SIB 72 03 19

RECALL 19V-XXX: REAR SEAT SAFETY BELT

This Service Information Bulletin (Revision 2) replaces SI B72 03 19 dated February 2020.

Remove rear upper seat belt

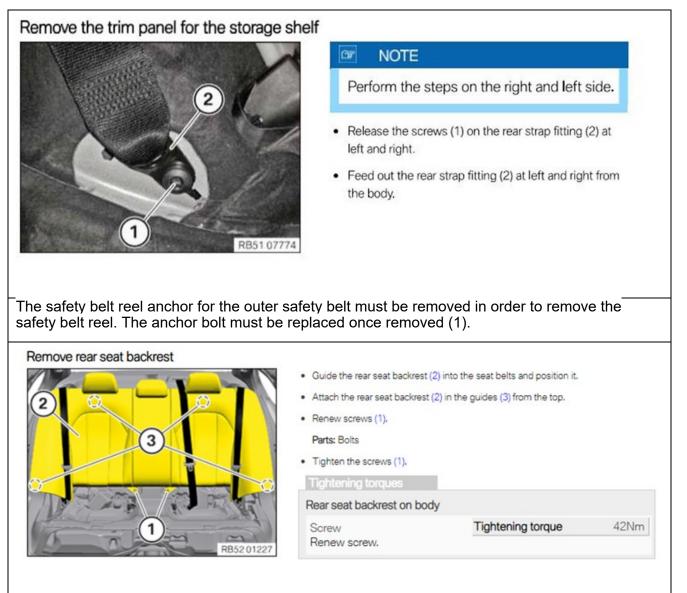
- Create a RECALL IDS ticket by VIN requesting the correct Part Number (beige / black) safety belt
- The safety belts' mounting screws must be replaced once removed
- · Most vehicles will require replacement of only one of the two safety belts

- Unlock plug connection (1) and disconnect.
- Loosen screw (2).
- Loosen screws (3).
- · Feed out seat belt retractor (4) towards the front.

The safety belts mounting screw must be replaced once removed. This is the large M10 bolt on the rear of the reel (2) The two small M6 bolts at the front of the reel can be reused (3).
